1CAN081203

Subject: ANO-1 Cycle 24 COLR, Revision 4  
Arkansas Nuclear One - Unit 1  
Docket No. 50-313  
License No. DPR-51

**ANO-1 Cycle 24 Core Operating Limits Report (COLR), Revision 4**

## **CORE OPERATING LIMITS REPORT**

**Figure 9A**

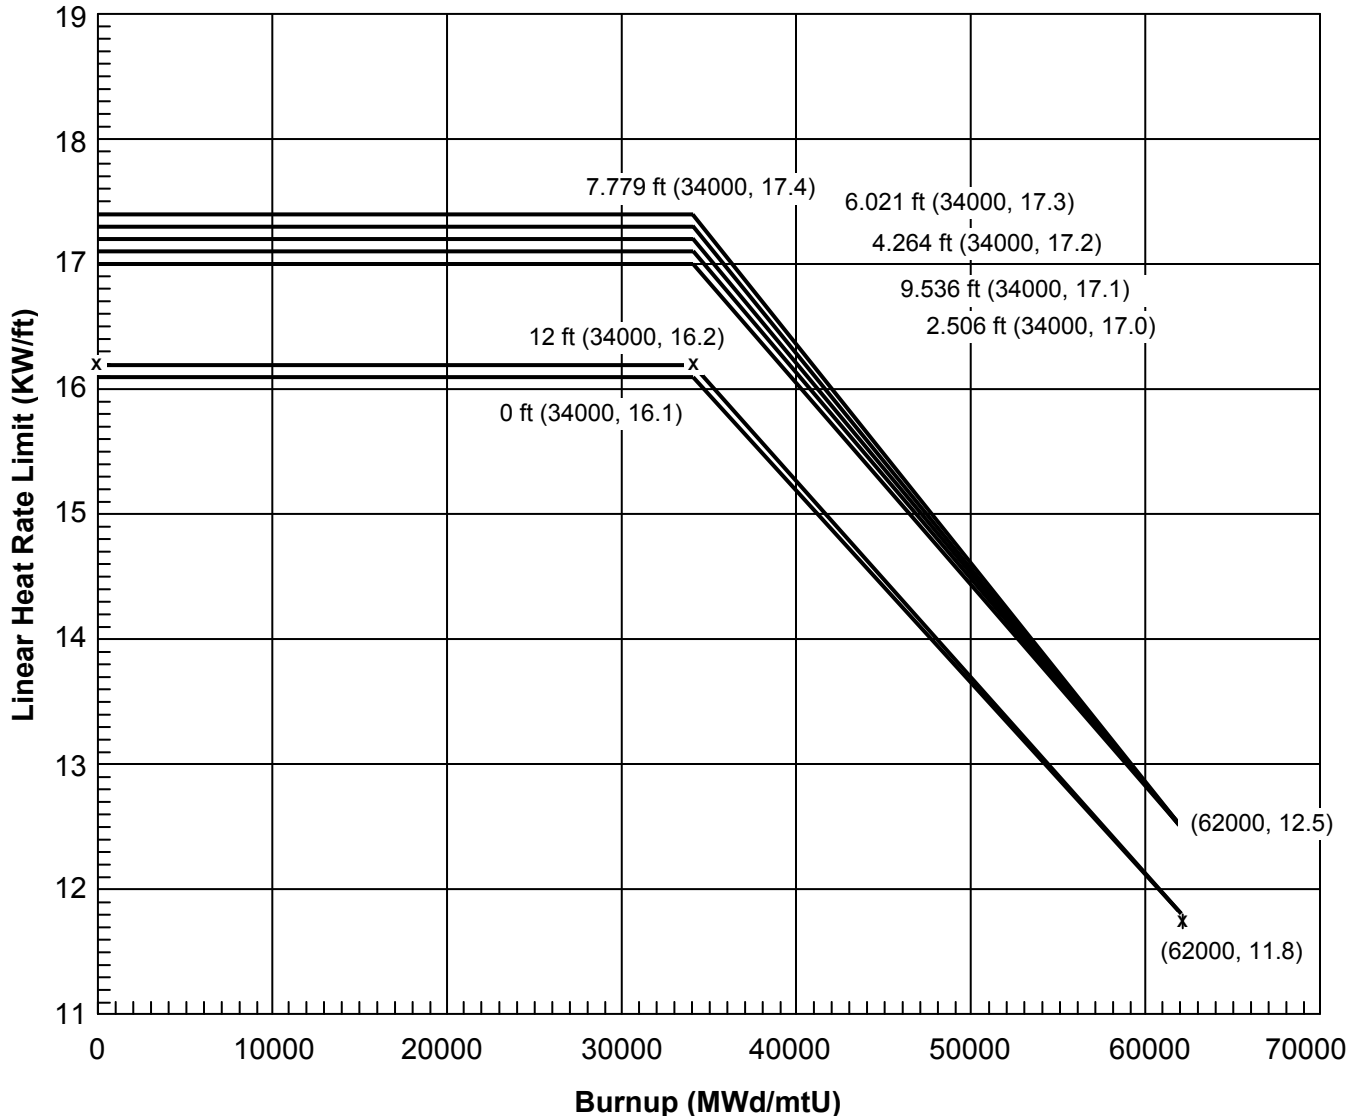
Revision 4 of the COLR corrects editorial errors which occurred during transition of the information in the COLR base calculation (reload report) to development of the COLR itself. Specifically, the zero (0) foot elevation at a core burnup of 34000 MWd/mtU was inadvertently listed as a Linear Heat Rate (LHR) limit of 16.2 KW/ft in Figure 9A versus the 16.1 KW/ft listed in the reload report. This error has no impact on unit operation and at no time has the LHR limit challenged during Cycle 24 operation. This condition is documented in the ANO Corrective Action Program. In addition, the parenthetical underneath the title on COLR Page 14 is revised to state "Limits" instead of "Figure." Finally, the applicable lines illustrated on Figure 9A are adjusted to more accurately reflect the stated endpoint of (62000, 12.5). No other limits or other information contained in the COLR are affected by this change.
